# UNITED STATES PATENT AND TRADEMARK OFFICE

| APPLICATION NO. | FILING DATE | FIRST NAMED INVENTOR | ATTORNEY DOCKET NO. | CONFIRMATION NO. |
|-----------------|-------------|----------------------|---------------------|------------------|
| 10/754,032      | 01/08/2004  | Michael Weiss        | WET 0122 PUS        | 6079             |

**Office Action Summary**

FIG.3

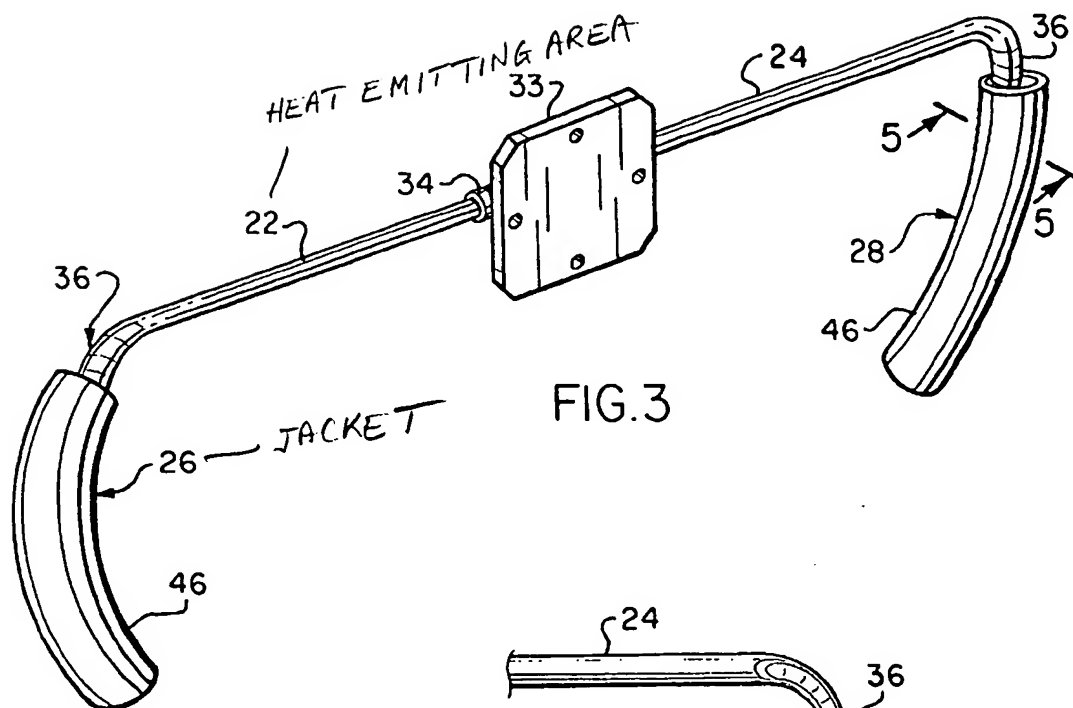
Regarding claim 1, Feher teaches a steering device 12 comprising a cooling device 10 arranged therein, the cooling device 10 comprising at least one heat pipe including at least one heat-absorbing area 36 (Fig. 3) and at least one heat-emitting area 22, 24, the at least one heat-absorbing area 36 being located in a grip region 16, 18 of the steering device 12. *Id.*, Figs. 1-10 and claims 1-17.

Regarding claim 17, the heat pipe comprises a closed tube having a transport device lining at least a portion of the inner tube wall and defining a fluid volume in the heat-absorbing area 36 and a fluid and gas-exchange volume in the heat-emitting area 22, 24 of the cooling device 10 as seen in Fig. 3.

FIG.5

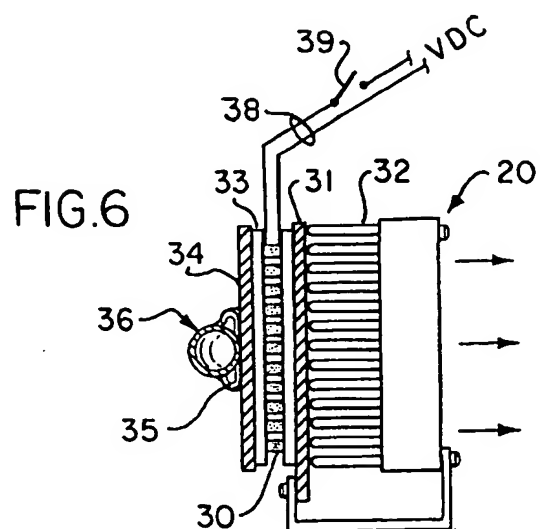
Regarding claim 4, the heat-absorbing area 36 is located within a circumferential annular groove 44 (Fig. 5) formed in the grip region 16, 18.

Regarding claim 15, Feher teaches a steering wheel comprising a toroidal grip portion 46 comprising a rigid core (Fig. 5, see Attachment) surrounded by a jacket 26, 28; a center portion (at 38 in Fig. 2) connected to the grip portion 46 by at least one spoke (at 42 in Fig. 2); and a cooling device 10 comprising a heat pipe including a heat-absorbing area 36 arranged in at least part of the grip portion 46 and a heat-emitting area 22, 24 arranged in at least part of the center portion (Att.).
